Remarks

II. Concerning the Amendments

Amendments to the Drawings:

FIG. 4

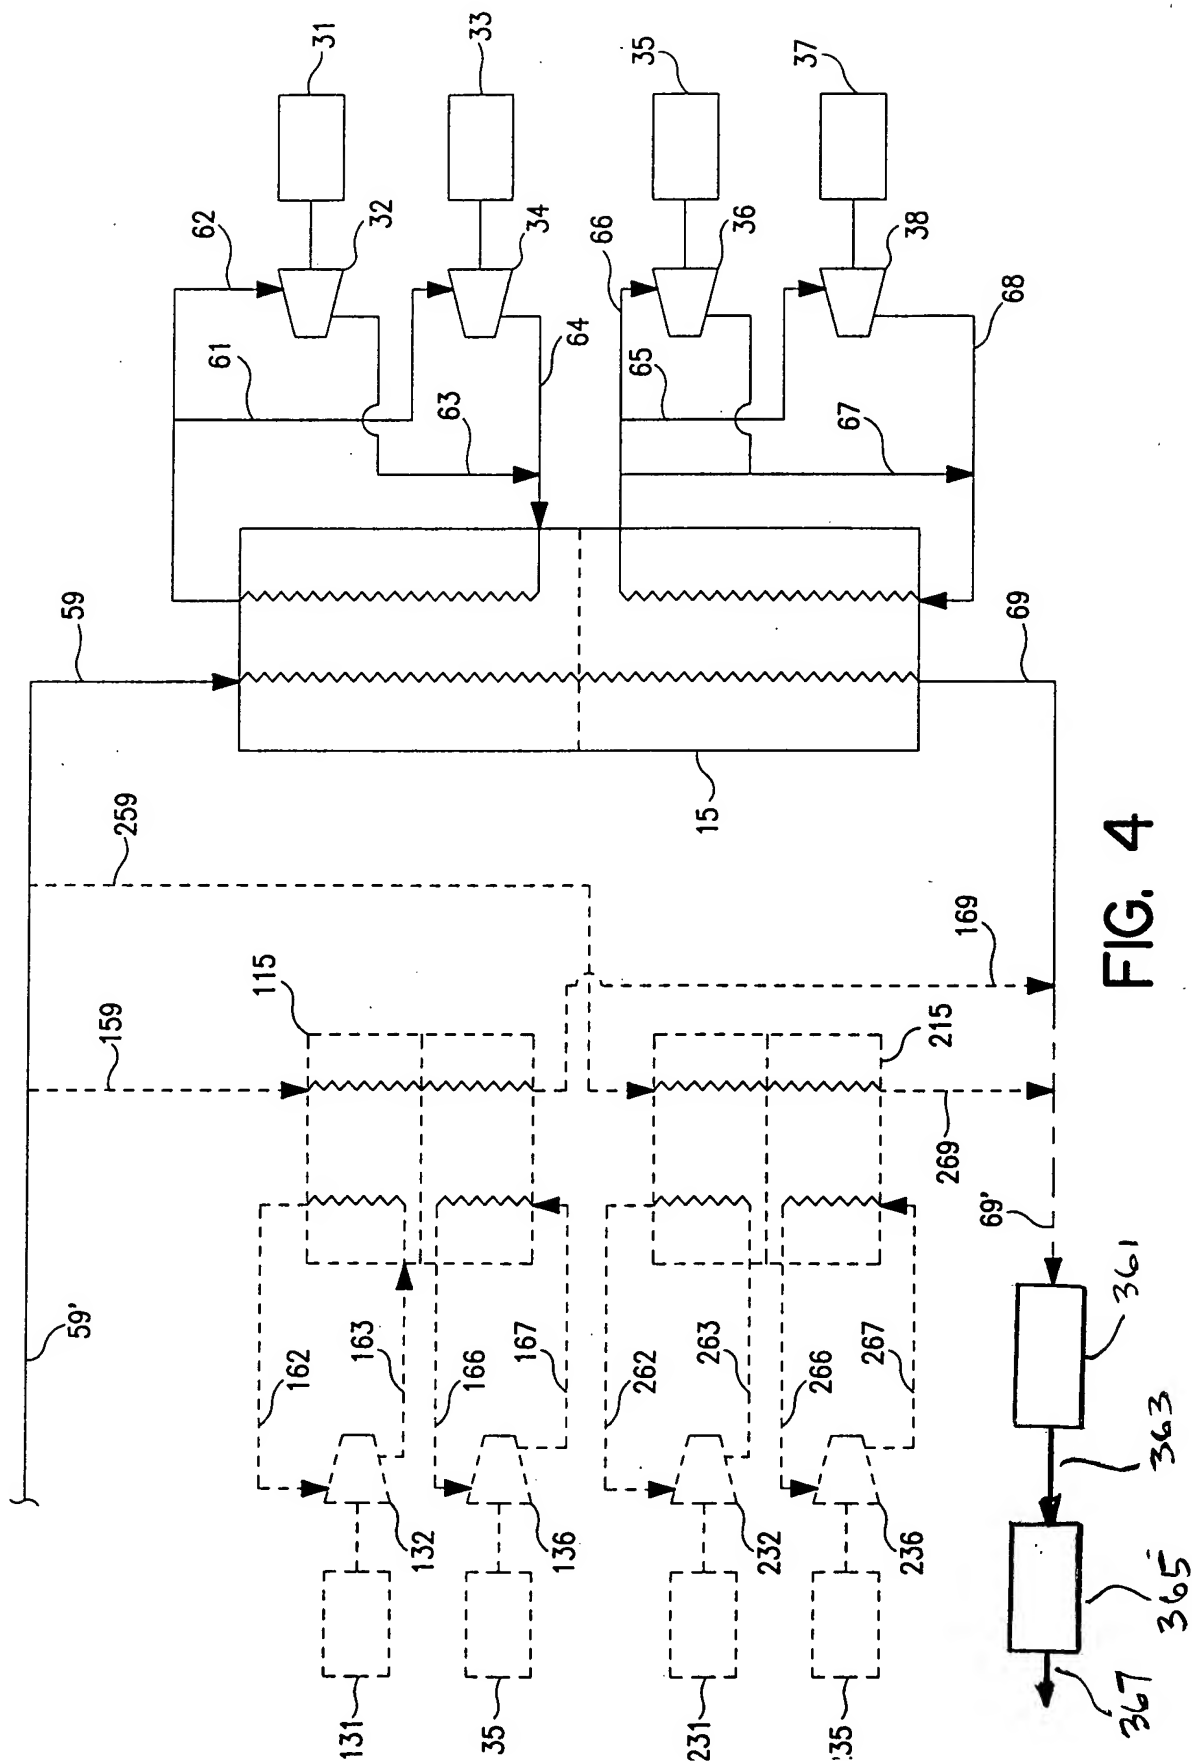
In the drawings, revisions to Applicants' Fig. 4 have been made to show generally operations associated with LNG product storage facilities 361 and LNG product shipping facilities 365, and connection lines 363 and 367. Such operations are generally known to the art and the Specification herein clearly mentions LNG product storage and shipping operations and facilities in a number of locations, such as page 2, line 9; page 5, lines 11-12; page 6, line 12; page 7, lines 10-11; page 8, lines 13-14; page 9, lines 15-17; and page 19, lines 4-8. The revised drawing shows no new matter and merely illustrates these operations positioned in their proper position with respect to the other steps of the process. The drawing revisions are considered to address the Examiner's objections to Applicants' Fig. 4 as originally filed.

In the Replacement Sheet for Fig. 4, previously omitted elements 361, 363, 365, and 367 have been added.

Attached hereto is a "Replacement Sheet" for Fig. 4 and also a copy of a drawing sheet labeled "Annotated Mark-Up Drawings" showing the original sheet with Fig. 4 marked up with the changes being requested herein. The Replacement Sheet is intended to replace the original sheet that includes FIG 4.
